**CAPITOL ZONING DISTRICT COMMISSION**  
**STAFF REPORT**  
**02/26/20**  
**DAC/BIM**

**Location:** 1317 South Spring Street  
**Applicant:** Ralph & Charlotte Patton  
**Permit Types:** Certificate of Appropriateness

**Project Description:** This application is for a Certificate of Appropriateness to allow for the construction of a new, two-story single-family dwelling and related site improvements. The approximately 3,183 square foot house will be covered in cement fiberboard (Hardie) lap-style siding over a masonry foundation. The concrete front porch features columns and a balustrade. Windows will be vinyl models with wood trim. The roof will be covered with architectural asphalt shingles. An attached two-car garage to the rear will be accessed from the alley by a driveway. The site plan also calls for a new concrete walkway from the sidewalk to the front porch, a privacy fence with an electric gate at the alley, and the removal of an existing tree in the center of the lot.

**SITE PLAN**  
1/8"=1'-0"

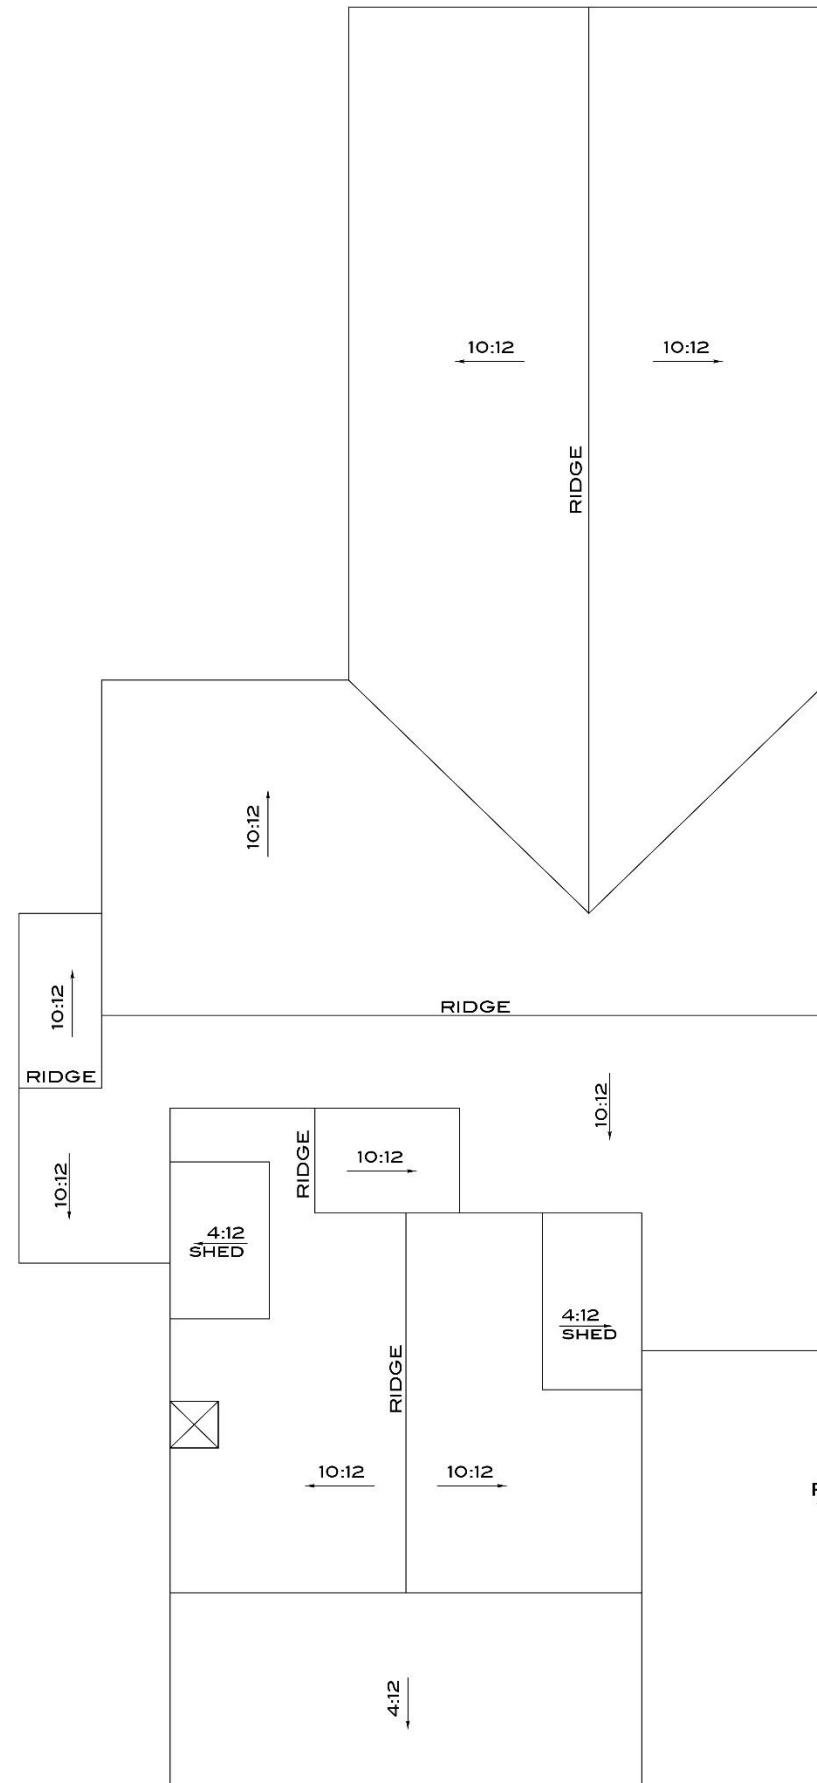
*Staff finds the proposal is consistent with the requirements. The plan calls for a 46.25' backyard and ~5.25' side yards.*

- 1) That all state and city codes be followed at all times;
- 2) That the property be maintained in a neat and safe condition at all times; ~~and~~
- 3) ~~That prior to issuance of a permit, a final plan will be submitted to staff showing:~~
  - ~~a. a front yard setback of not less than 25 feet;~~
  - ~~b. the height and materials of any fencing; and~~
  - ~~c. the location and species of the tree or trees replacing the tree to be removed.~~

***Applicants have submitted revised plans showing these details.***

Setback-That is an architect error. We are aware of the 25 foot setback and that is what will be done. Hope this is acceptable without paying more to the architect to correct?

Attached are the revised plans to include the conditions and suggestions. For the fence, looking at the floor plan on the left north side it will begin at the Kitchen and on the right north side it will begin at the Powder room. This will be a 6 foot privacy fence with an automatic slide gate in the alley for the driveway. The pecan tree will have to come down. The big, I think oak, at the southwest corner of the lot will stay but be trimmed. Will replace pecan tree in yard on north side of sidewalk with a maple tree.

FRONT ELEVATION

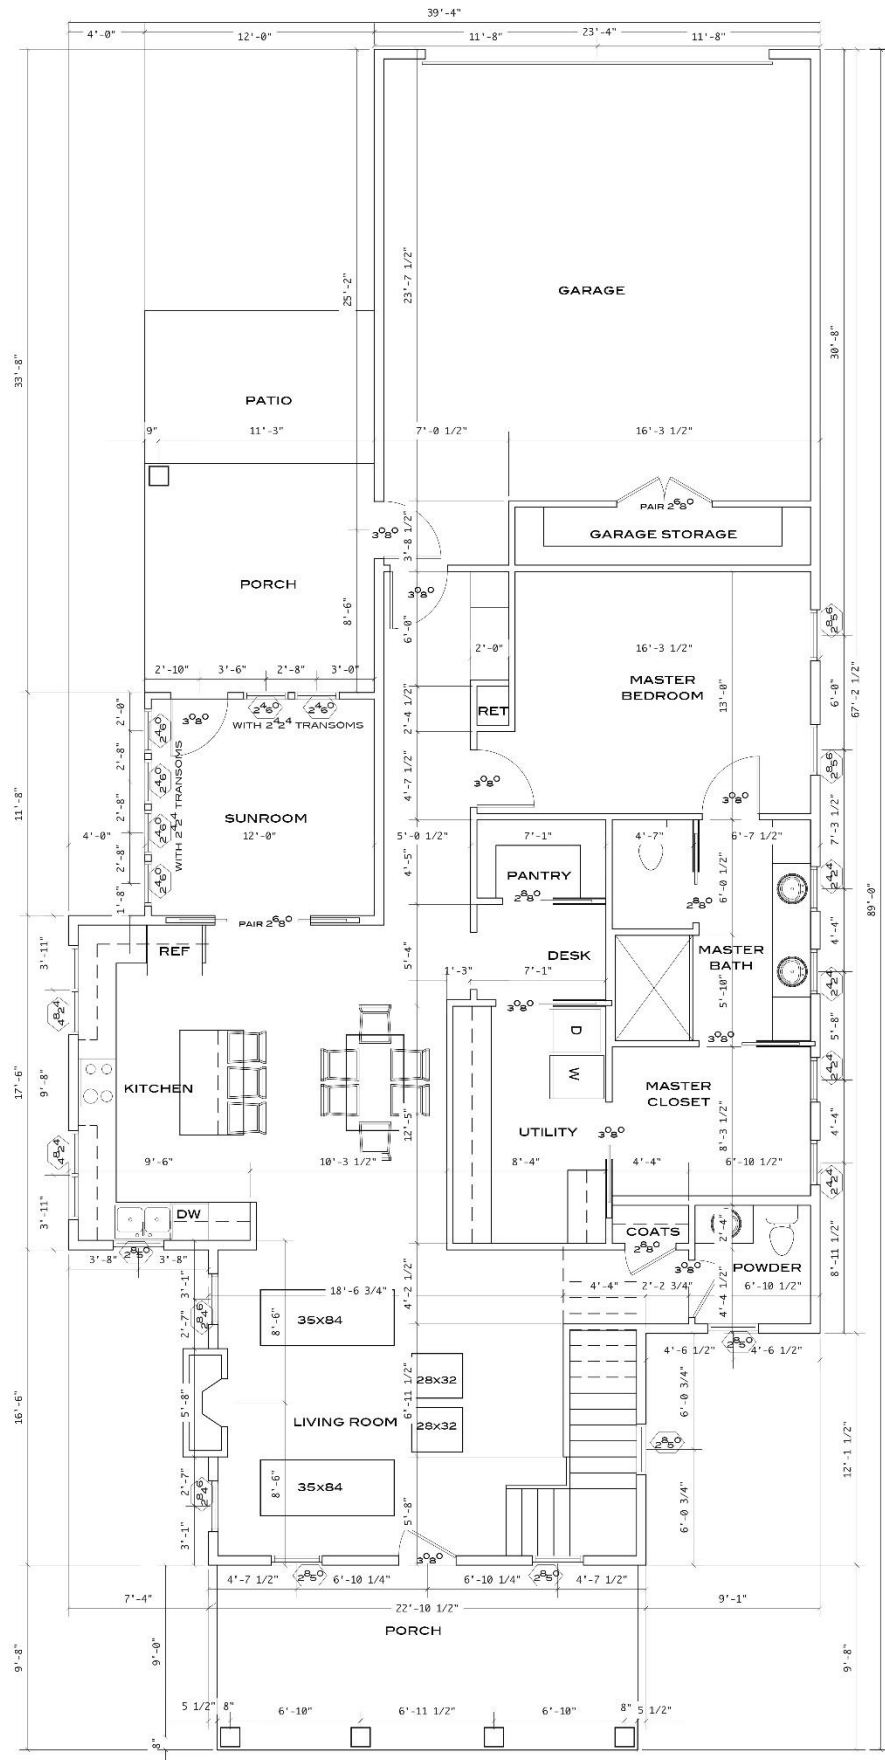
- ~~4) That the final elevations include:~~
  - ~~a. an attic vent in the front gable;~~
  - ~~b. an additional window near the front of the house on the right (south) side; and~~
  - ~~c. some separation between the porch roof and front gable window, by raising the window and/or reducing the pitch of the porch roof.~~

~~Committee members also suggested the applicants consider “centering” the first floor front window on the right side.~~

***Applicants have submitted revised plans showing these details.***
